Products: MLR-850
Serial Range: Beginning with R8500067
Release Date: May 30, 2016

Thermocouple and High-Limit

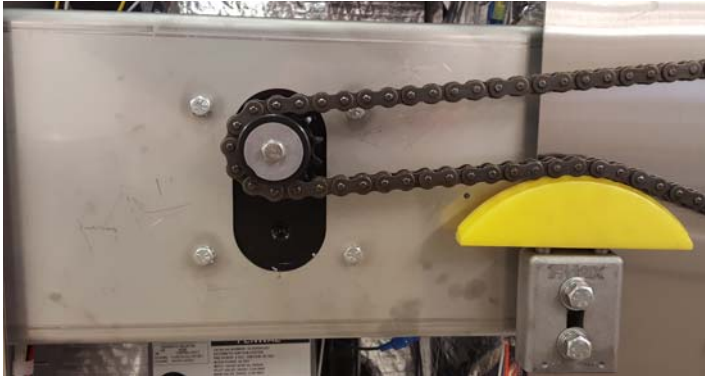
The high-limit switch will move from being located on the outside of the service bay in the rear of the smoker to being located on the same panel as the thermocouple at the front of the smoker. The thermocouple and high-limit will remain the same; only the mounting plate and gasket will change.
